Drawing below is represents modification recommended on DRV ducting system when main duct has THREE 6" discharge Ducts

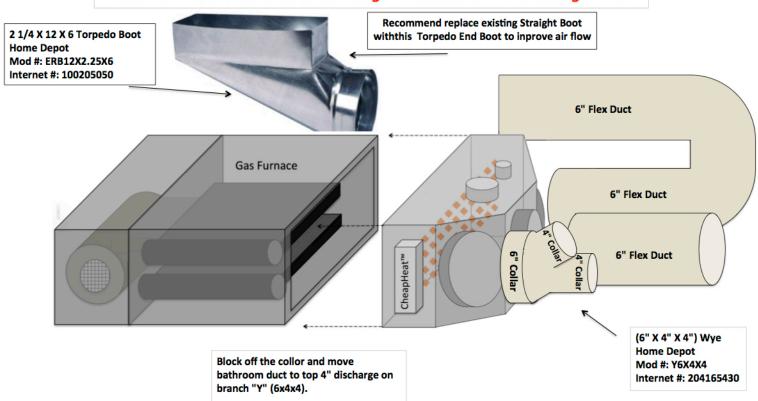
Drawing below is represents modification <u>needed</u> on DRV ducting system when main duct has TWO 6" discharge Ducts and ONE 4" discharge Duct
